September 5, 2017
Medway Planning and Economic Development Board
Medway Middle School, 45 Holliston Street
Medway, MA 02053

CHOATE PARK SITE PLAN – Public Hearing

- Public Hearing Notice
- Project Description
- Site Plan Application
- Site Plan
- Requests for Waivers
- Development Impact Report
- Cost Estimates
- Public Survey Results
- PGC Review Comments dated 8-29-17
- Tetra Tech Review Comments dated 8-31-17

Development Name: Improvements to Choate Park and Cassidy Fields
Plan Title: Choate Park, Site Improvements Plan
Plan Date: August 17, 2017
Prepared by:
Name: Denis J. Chagnon, ASLA CPSI
Firm: CBA Landscape Architects LLC
Phone #: 617-945-9760 x 2
Email: dj@cbaland.com

Steel Bollard with Chain

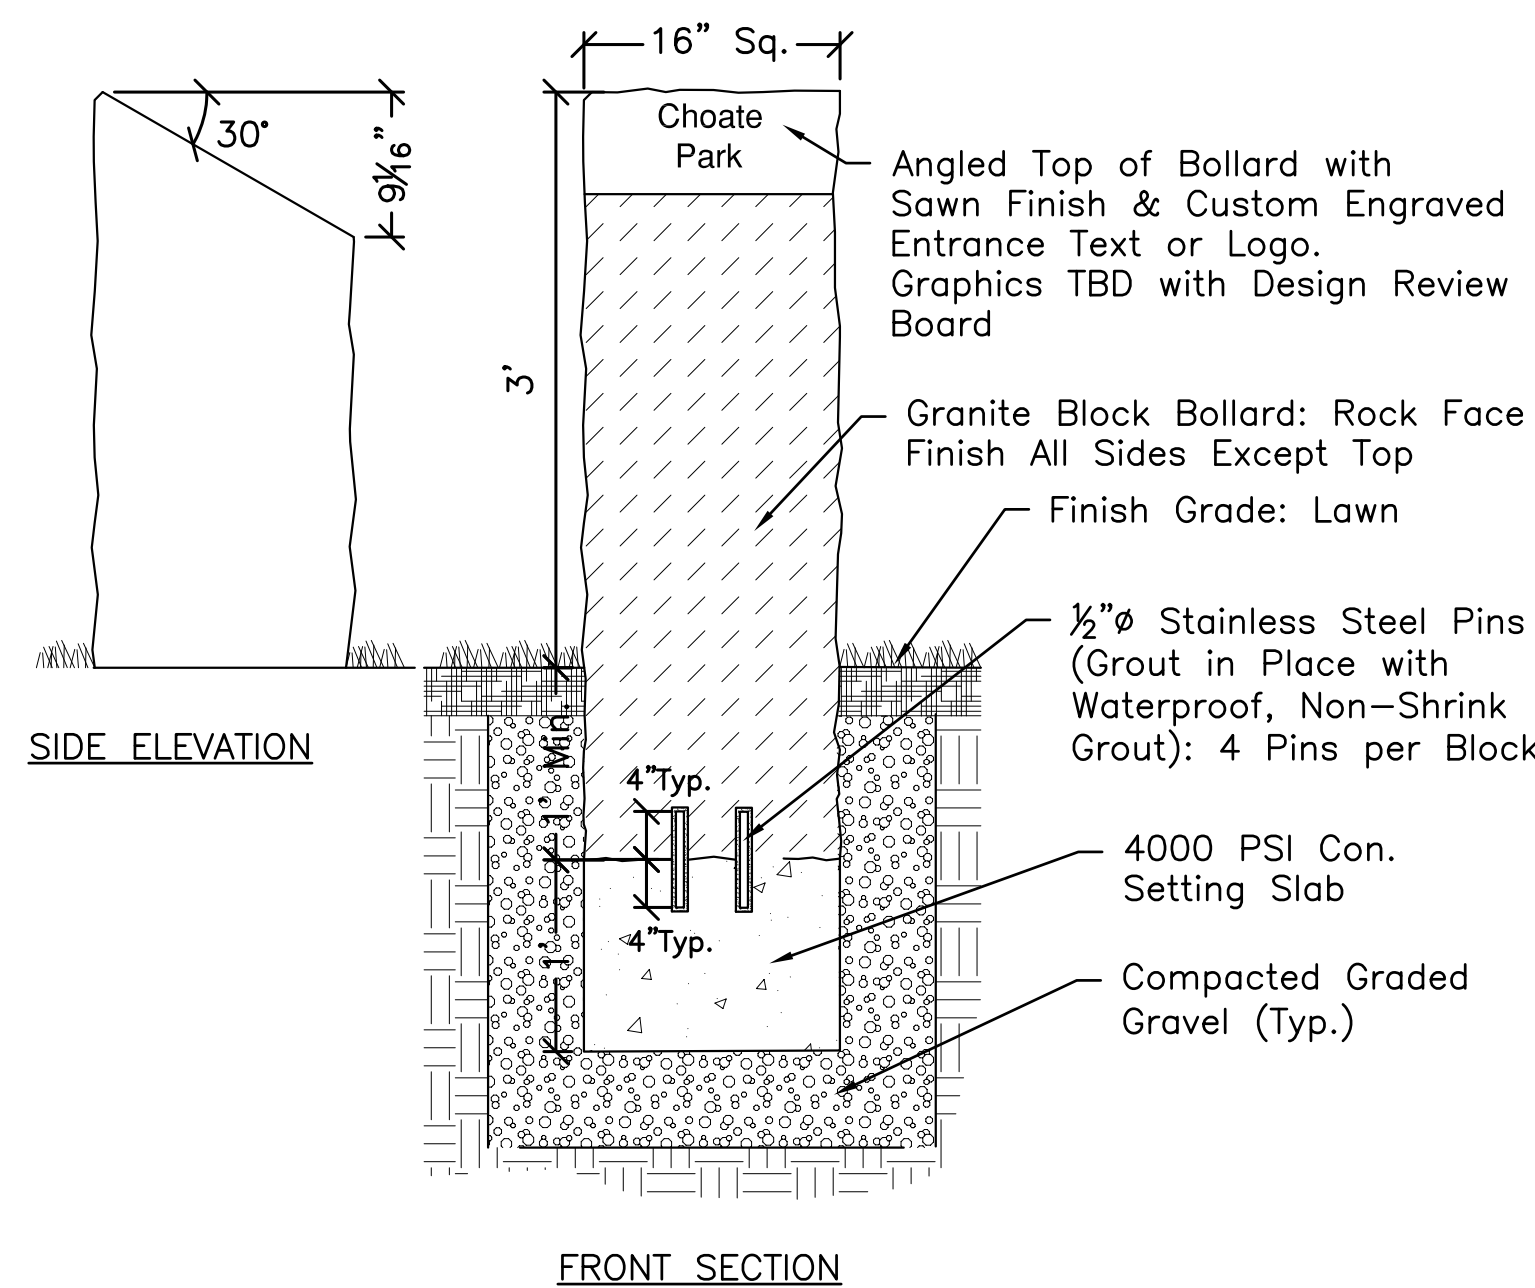
It was explained that there were several meeting prior to this with input from a variety of Town boards/committees and residents. There was discussion about the bollard and chain in the parking area. This was suggested to block off the area for camp. A question was raised about who will be responsible for the control of the chain (opening and closing). Consultant Reardon responded that regular police barricades work well and he indicated that chains and bollards are really dangerous.
